DUANE ARNOLD

SITE-SPECIFIC OFFSITE RADIOLOGICAL
PREPAREDNESS ALERT NOTIFICATION SYS
QUALITY ASSURANCE VERIFICATION

DUANE ARNOLD ENERGY CENTER
SITE-SPECIFIC OFFSITE RADIOLOGICAL EMERGENCY
PREPAREDNESS ALERT AND NOTIFICATION SYSTEM
QUALITY ASSURANCE VERIFICATION

September 14, 1989

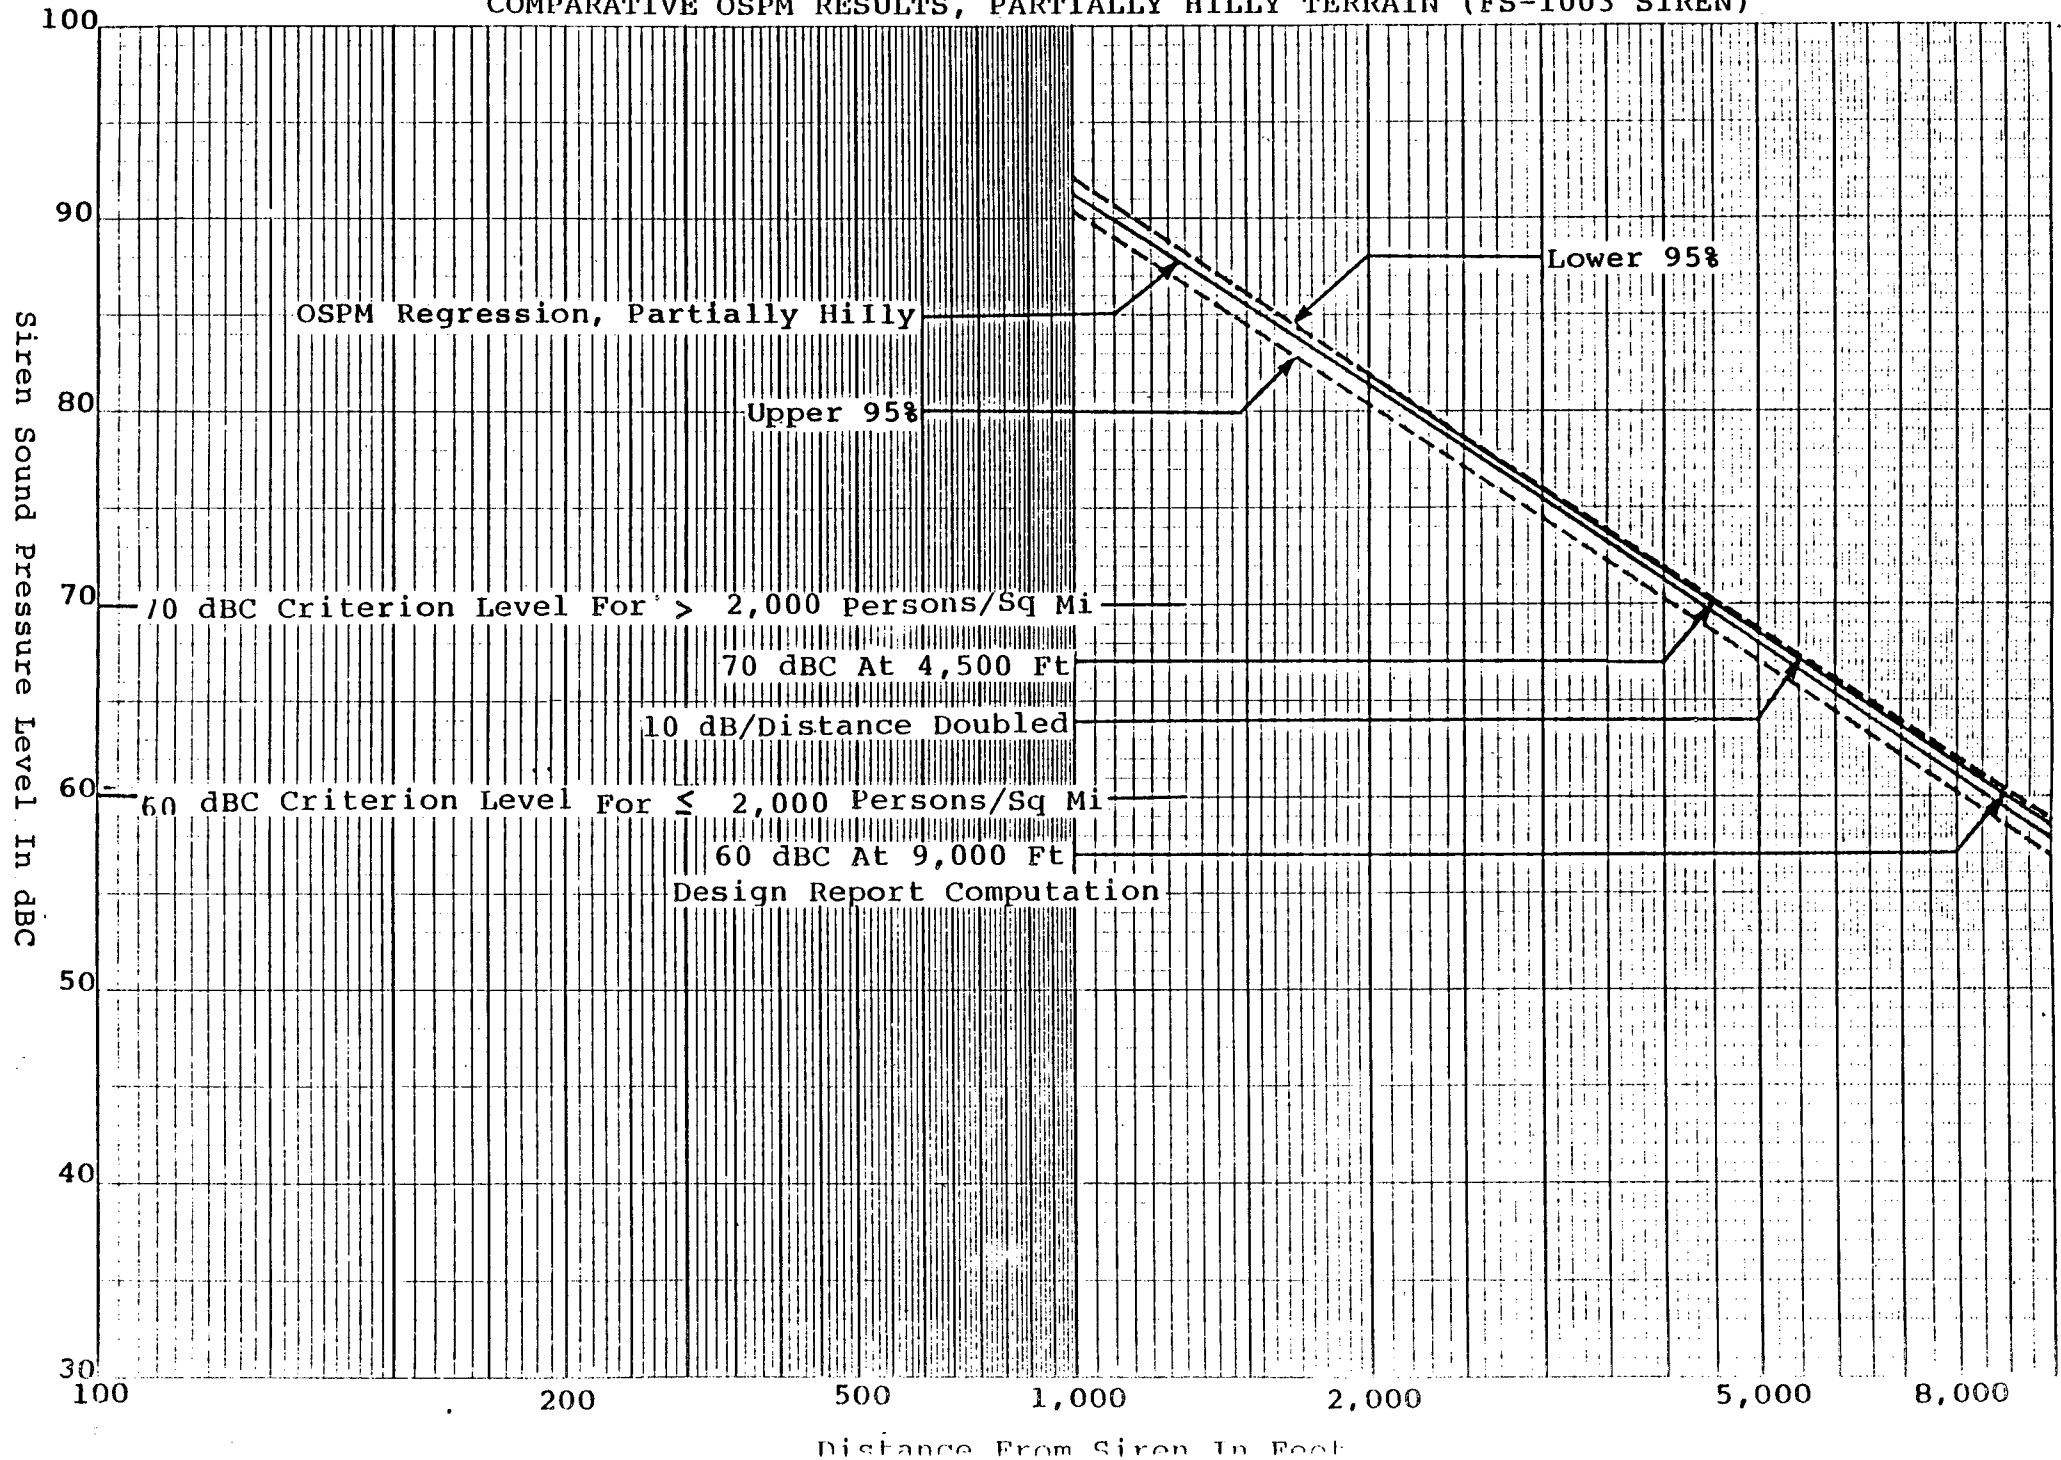
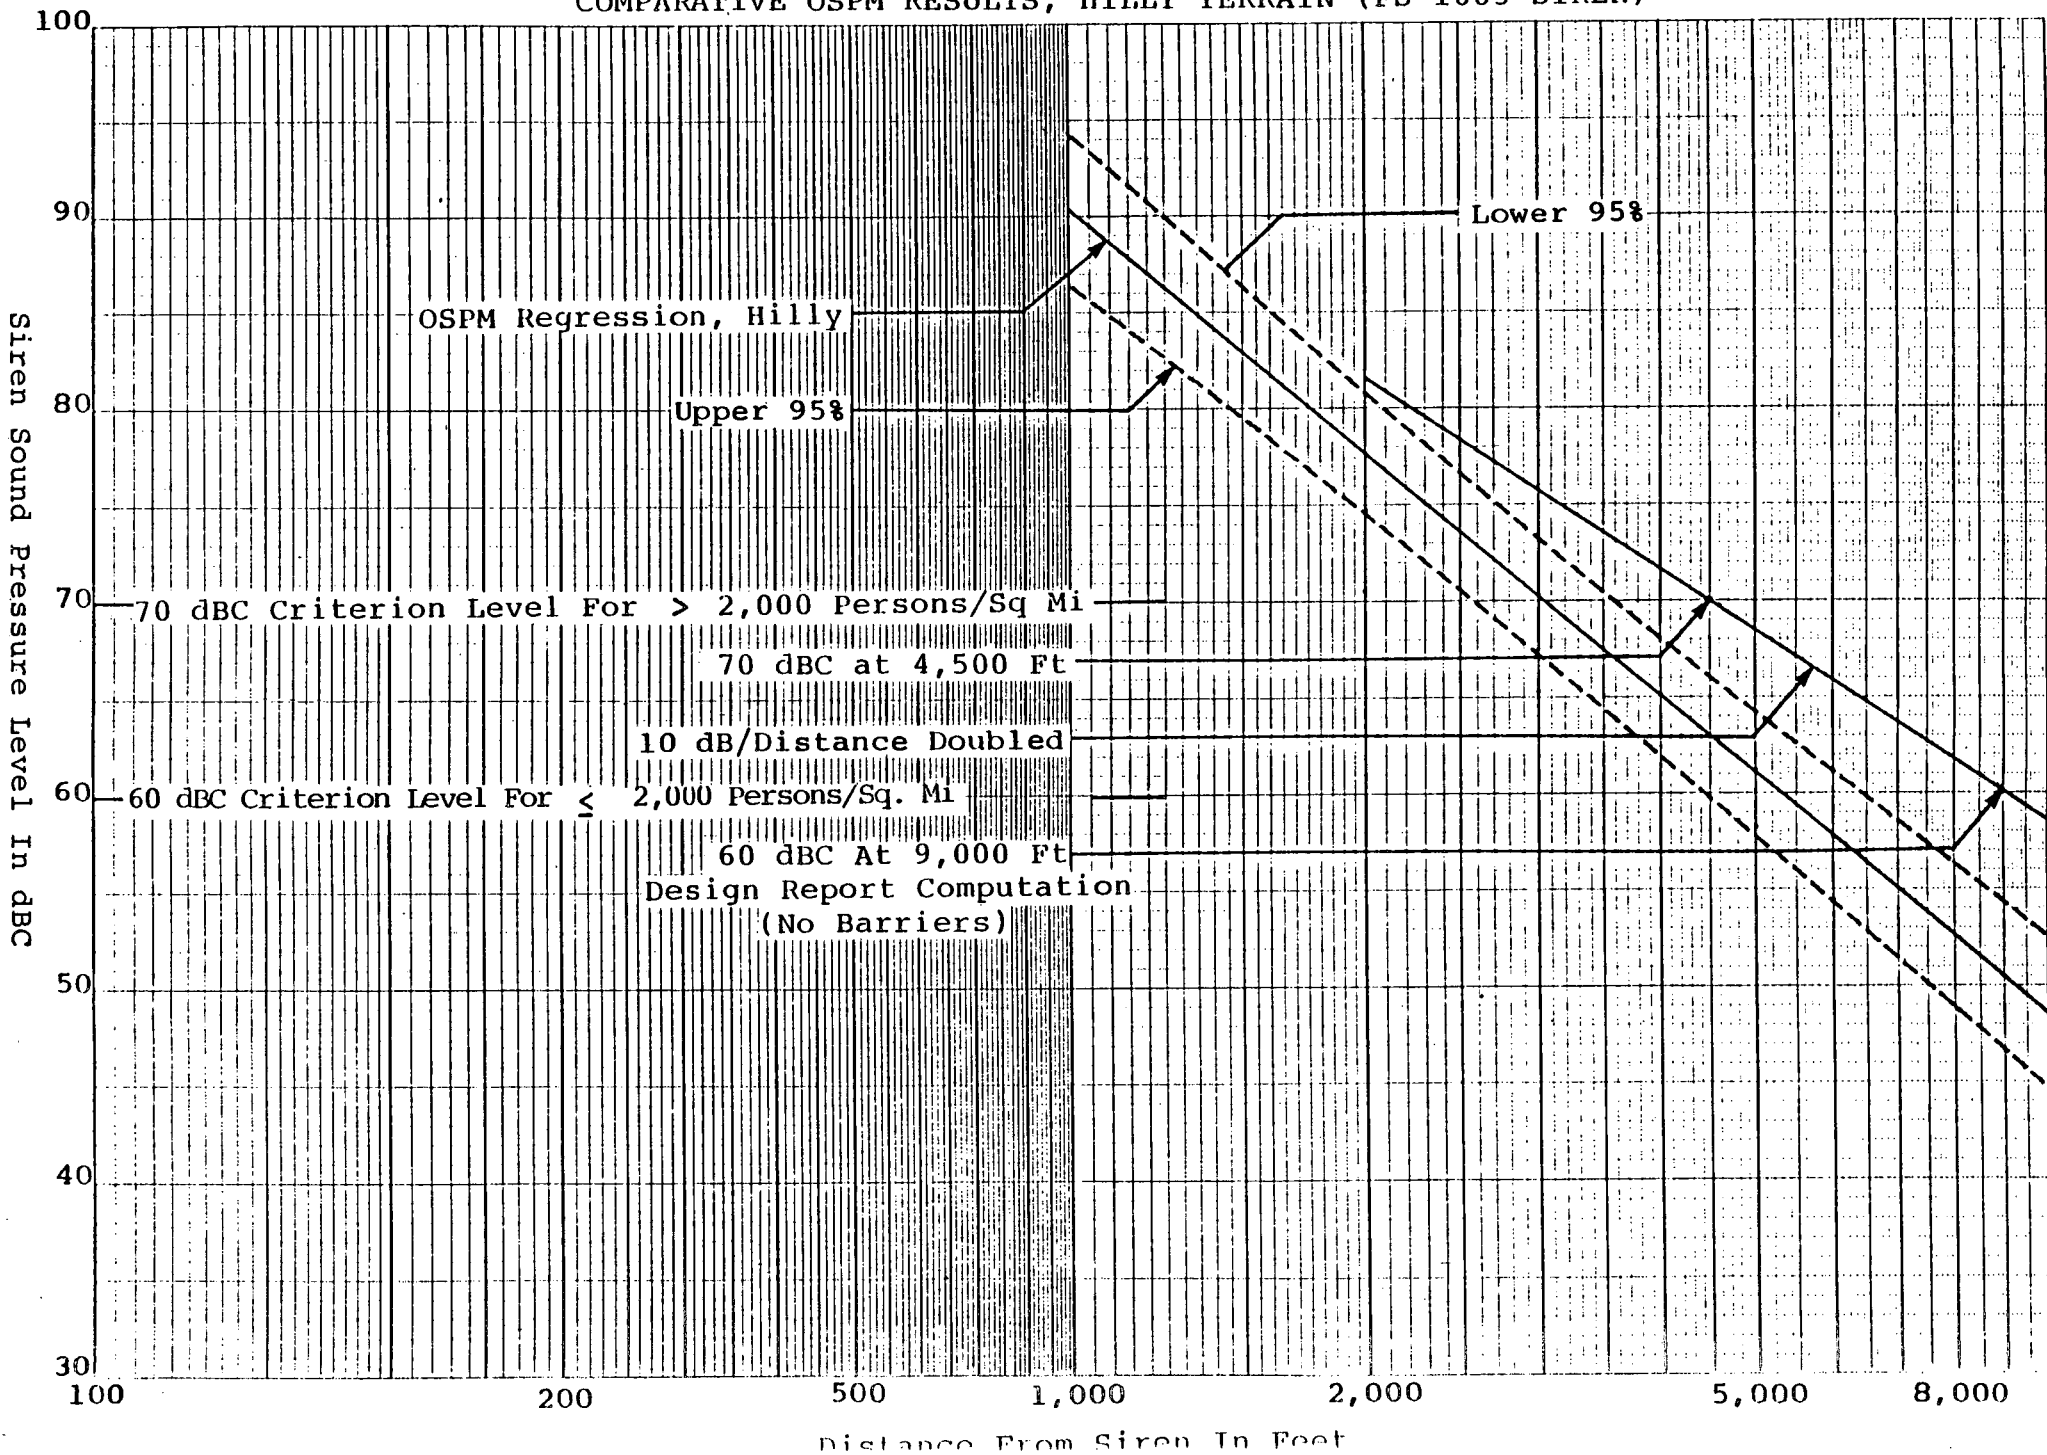
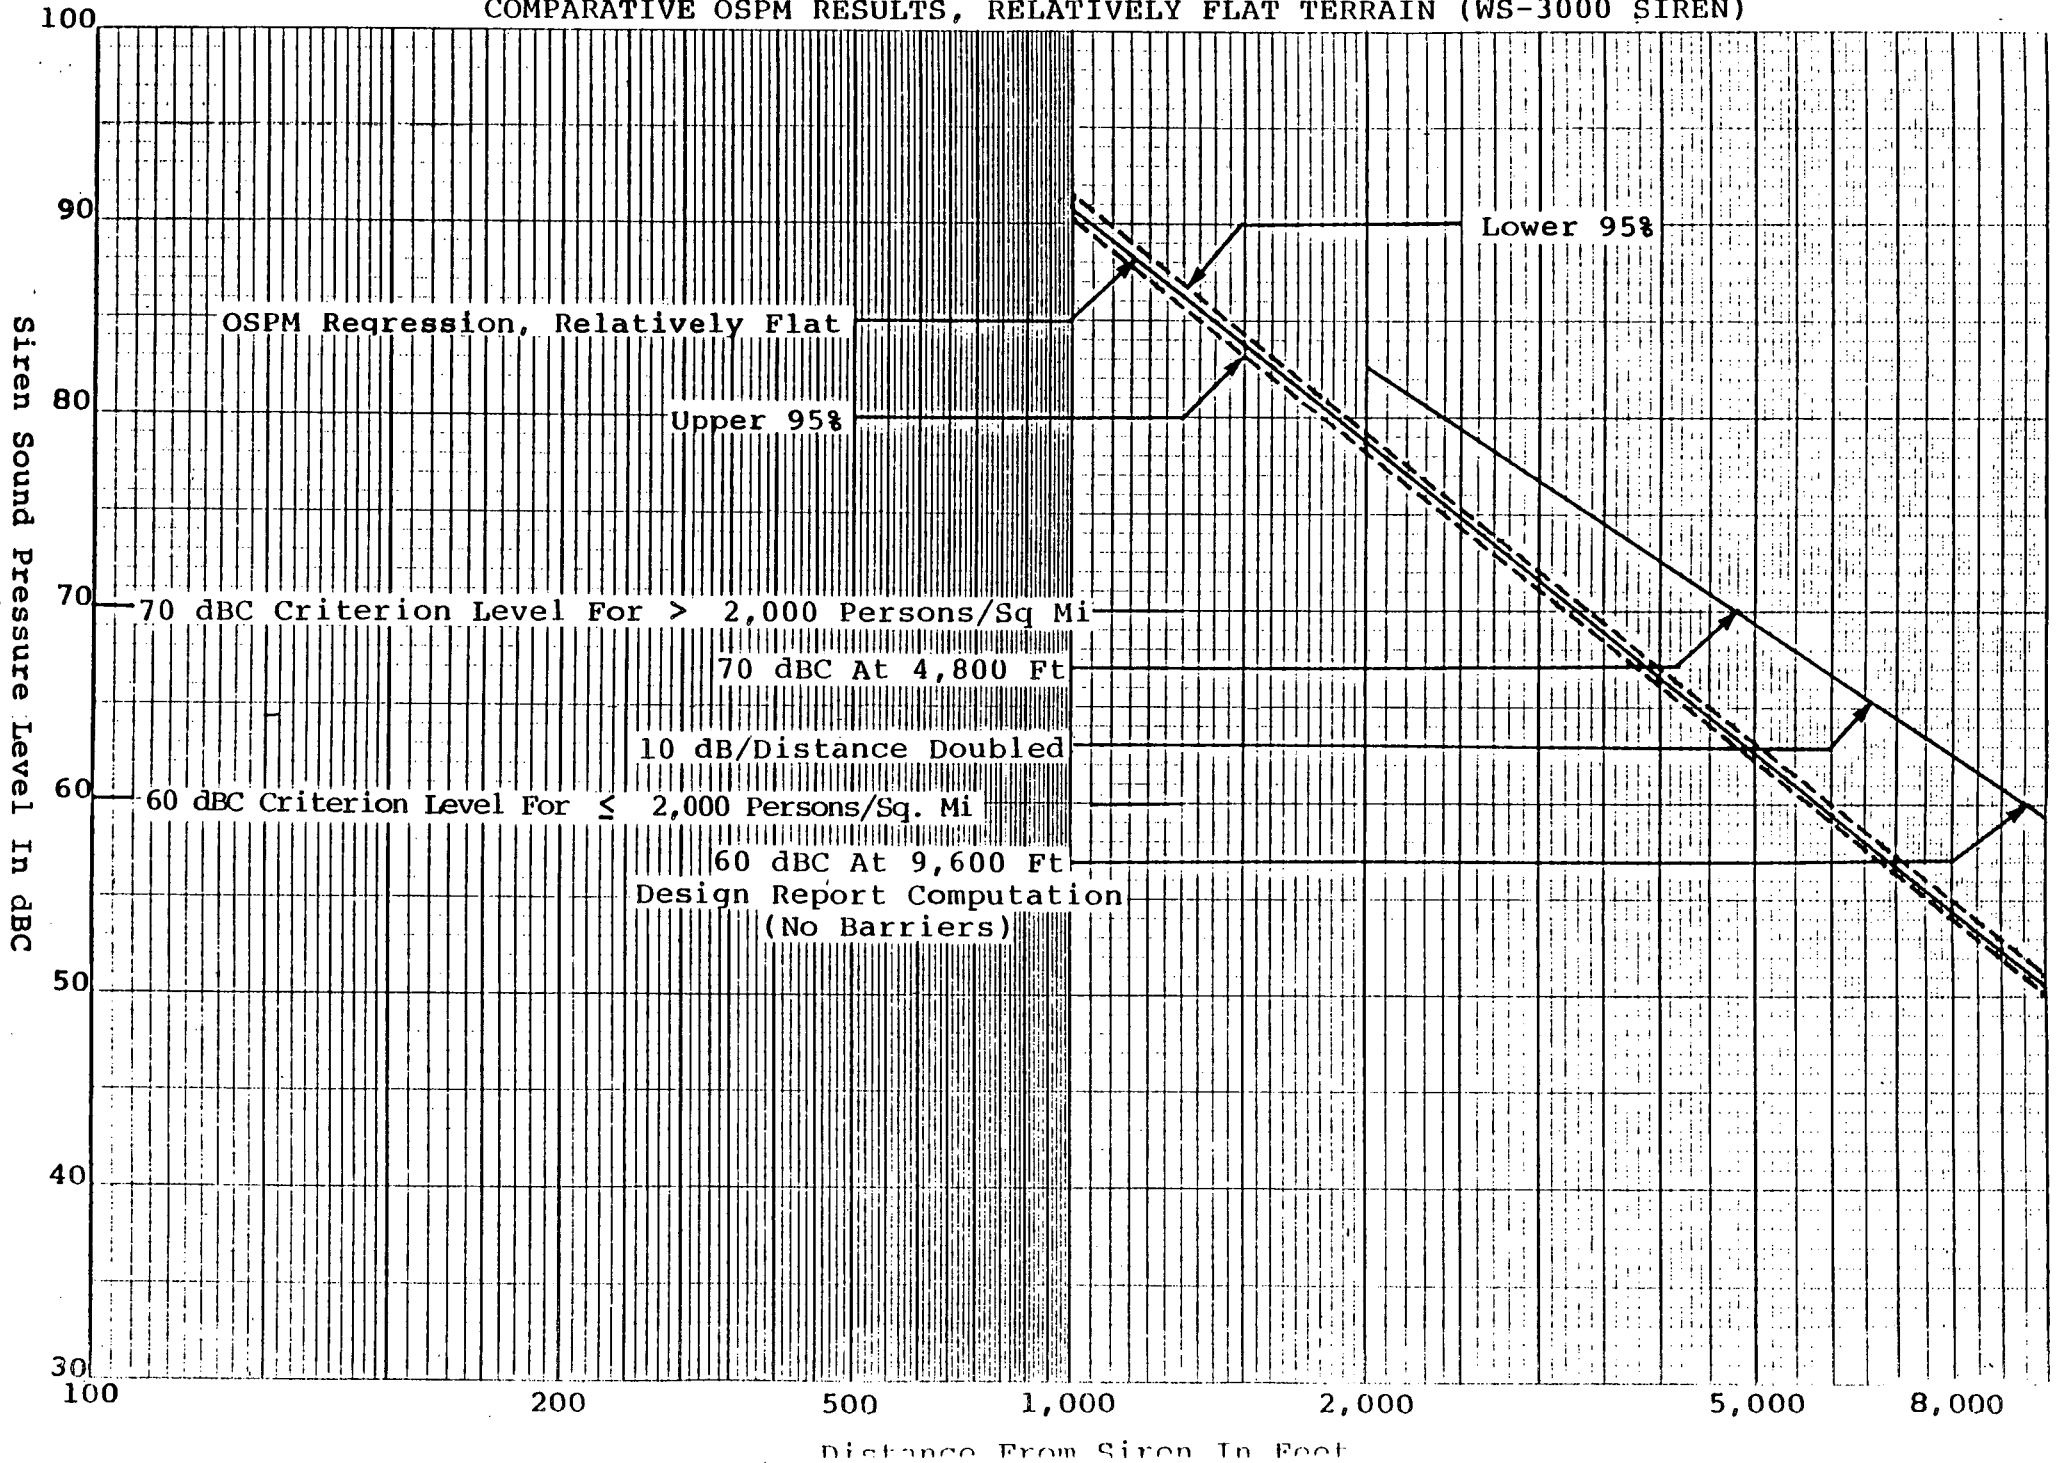
The OSPM regression results of the siren sound pressure levels are presented in Figures 3 through 8 of this report. Also depicted are the ranges of 60 dBC and 70 dBC as calculated by the licensee using the 10 dB loss per distance doubled attenuation rate with no barriers. The following table summarizes the estimated effective ranges of 70 dBC and 60 dBC over the various terrain classifications:

Some general observations can be made concerning the siren range comparisons. The 60 dBC and 70 dBC ranges estimated by the licensee for the FS-1003 sirens over partially hilly and flat terrains are similar to OSPM results. With proper terrain adjustments, the effective 70 and 60 dBC ranges would be greatly reduced as demonstrated above.

The licensee's estimated 60 dBC and 70 dBC ranges for the WS-3000 sirens, however, are very liberal compared to OSPM results. This is due to the higher operating frequency of the WS-3000 siren which suffers much higher attenuation rates through atmospheric absorption and other excess attenuations. The effective range of the WS-3000 siren is therefore substantially reduced from the 10 dBC rule which is based on operating frequencies of 500 to 800 Hz. This is particularly so for the 60 dBC range, since the attenuation rate in the 1,000 Hz octave band is typically much greater than 10 dB per distance doubling at large distances (5,000 ft. and beyond).

These derived radii confirm that on the average, the Design Report siren ranges are liberal when site terrain and weather conditions are taken into account.
